PARKSIDE MALVERN RESIDENTS ASSOCIATION

Our reference: consultation letter 1

22nd April 2024

Re: Re: HGY/2024/0466 - 157-159, Hornsey Park Road, London, N8 0JX

Appendix 1 – ‘Small site/Backland’ development accessible only from Hornsey Park

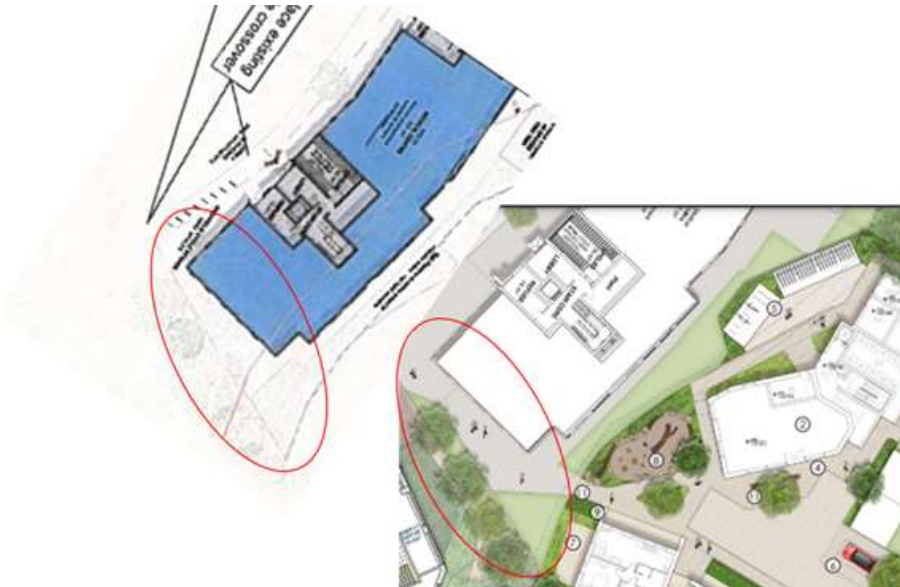
- 1.5 By reference to 1.4 above, the development densities, capacity and flexibilities granted by the Site Allocations Plan for more intensive development of the 'central' metropolitan area and Western Heartlands are not applicable. The site is de facto landlocked by the recently re-approved Iceland development and is for all practical purposes accessible only from Hornsey Park Road via an existing, narrow access driveway between private residences unsuitable for its intended purpose;

- 2.1 Against the wishes of the local community, the site was reallocated to the Western Heartlands development area in the SAP 2017 for the specific purpose of integration with that area. The site was then and by this application undeniably remains a 'small site'/Backland site', effectively occupying the space of back gardens in the line of houses on the west site of Hornsey Park Road (see Appendix 1). As such, Policy DM1 must be applied where proposals '*should relate positively to their locality, having regard to, building heights, form, scale & massing prevailing around the site, urban grain, sense of enclosure, following existing rhythm of any neighbouring or local [density] and distinctive local architectural styles, detailing and materials*';

Appendix 3 – Site orientation and access for all purposes including community cohesion, foul and surface water drainage, district energy network (DEN), service deliveries, power, telecoms and emergency services

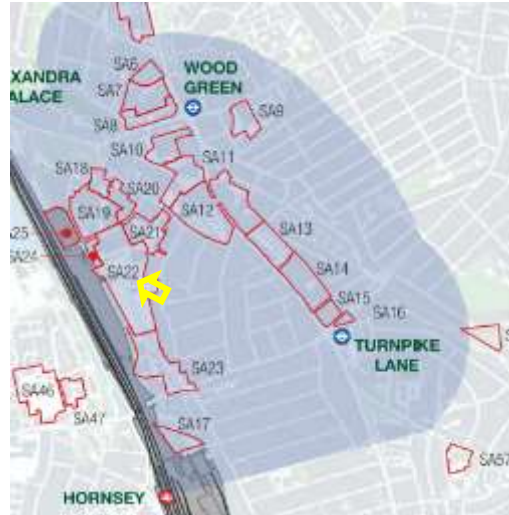
- 1.9 The proposal should as a minimum seek to create a landscaped shared surface access from Brook Road, integrated with the need for access to the Iceland development: this should be designed to create openness and compliment, not detract from the adjacent Moselle Walk now under construction;

- 3.6 The access from Hornsey Park Road should be a subsidiary access with a new access from Brook Road created to fulfil the objective of creating a linkage with the Western Heartlands and wider 'Clarendon Gateway' site. The existing access should be for pedestrians, cycles and emergency vehicles only and be properly landscaped, including treatments to the flank walls of adjacent houses;

Appendix 4 – planning policy for strategic planning followed 1997 planning permission

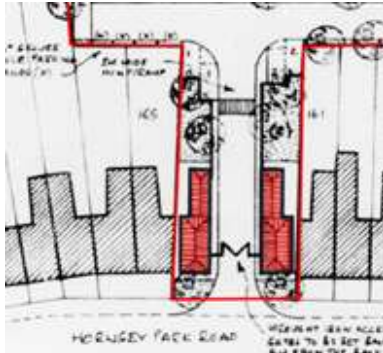
- 1.11 The proposed intensity of development should not be permitted as there is inadequate access for construction traffic from Hornsey Park Road. It was the site owner's or previous site owner's decision to narrow the existing access when it built two detached houses under planning permission HGY/1997/1667 at which point Haringey's planning officers' decision to approve brought with it the need to orientate development and access towards Brook Road and the Western Heartlands. Planning policy has been consistent for more than 25 years to ensure this reorientation yet this application has been allowed to ignore it. The applicant and Haringey must accept that the grant of permission irrevocably denied the opportunity to develop from Hornsey Park Road.

- 6.2 The planning history of a site is a relevant consideration in the determination of this application. Given that policy and the Local plan have been developed and consulted on for the Western Heartlands and Sites SA21 and SA22 following implementation of HGY/1997/1667, the absence of orientation towards Brook Road as part of the Clarendon Gateway and need to restrict access to HPR are material considerations;

Appendix 5 – EA strategy becomes impossible when Haringey circumvents its adopted development strategies and policies

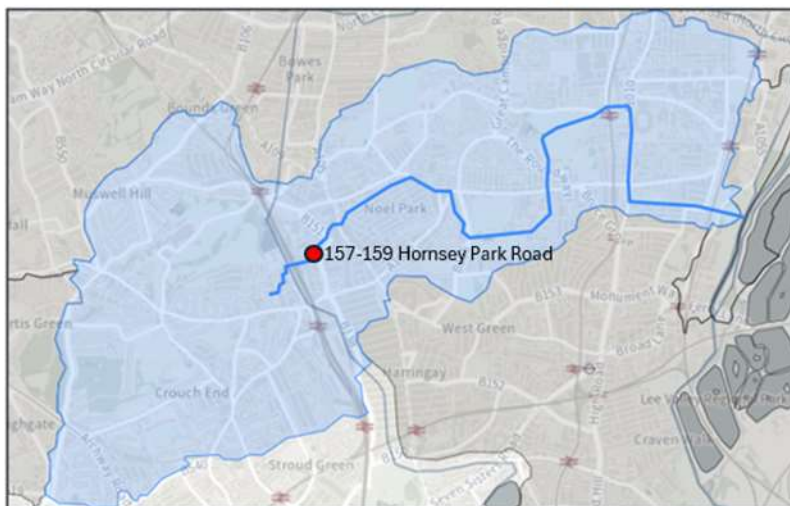
- 4.3 Seeking to determine the application's height and density by reference to SA21 but then treating it as a 'small/Backland' site for the purposes of Blue Ribbon and EA policy has given the appearance that Haringey has sought to circumvent policy to support the applicant. We note that the initial objection from the Environment Agency (EA) has been revised during the application consultation to align with planning officers' 'pre planning advice' given last year. Specifically, the EA appears to have been led by Haringey to consider the application as a 'small site/Backland' where daylighting could be considered 'Disproportionately expensive/ Disproportionate burdens' under EA classifications (see Appendix 5), whereas Haringey's primary policy is SA21 clearly has the greater objective of 'Regeneration /Masterplanning'. If taken as one larger site, daylighting the Moselle, where the Water Framework Directive status classification is for the greater part 'Good' (see Appendix 5) and the 'Year' for achievement is 2027, becomes achievable by following extant policies. This should be a focus of planning officers. In the absence of a proper assessment in relation to SA21, Haringey's approach has become procedurally problematic and calls into question the integrity of planning governance.

NB: see WFD mitigation measures assessment classification for explanation of 'Moderate' : of 31 'Classifications', all but two are 'Good' and two are 'Moderate', giving the Moselle an overall Classification of Moderate. Of the two Moderate classifications, one is '**Biological quality elements**' which is the responsibility of Haringey to mitigate through **Buildings Regulation, managing misconceptions and enforcement** and the other is '**Invertebrates**' where Mitigation is recoded as 'Disproportionately expensive/Disproportionate burdens'. Expense is related to site conditions which requires knowledge of site conditions and a detailed assessment of feasibility.
